Intel® Celeron™ Processor Specification Update

Release Date: November 1998

Order Number: 243748-008

Figure 20. Side View Space Requirements for the Boxed Processor

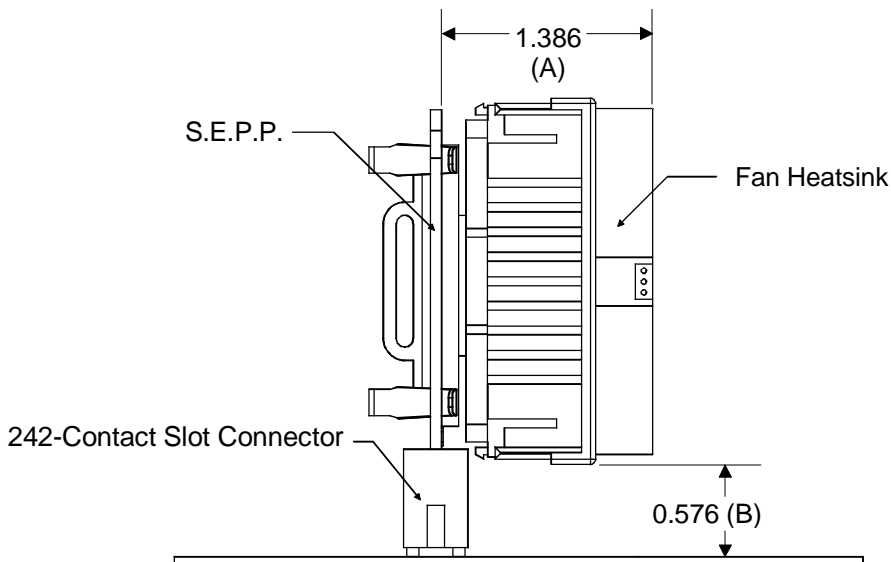
Figures 20, 21, and 22, and Table 34 of Section 6.2 of the *Intel® Celeron™ Processor at 266 MHz, 300 MHz, 300A MHz, and 333 MHz* datasheet show incorrect fan heat sink dimensions for the boxed Intel Celeron processor. The correct figures and table are shown below.

The maximum depth of the fan heat sink to the processor substrate should be 1.386", not 1.291" max. The minimum height clearance above the baseboard should be 0.576", not 0.485". The fan shroud height should be 2.02" and 4.74", respectively, not 2.19" max. and 4.90" max. Figure 22 should show reference "G" for the minimum airflow keepout zone from the inlet of the fan heat sink, and reference "F" for the minimum airflow keepout zone from the ends of the fan heat sink.
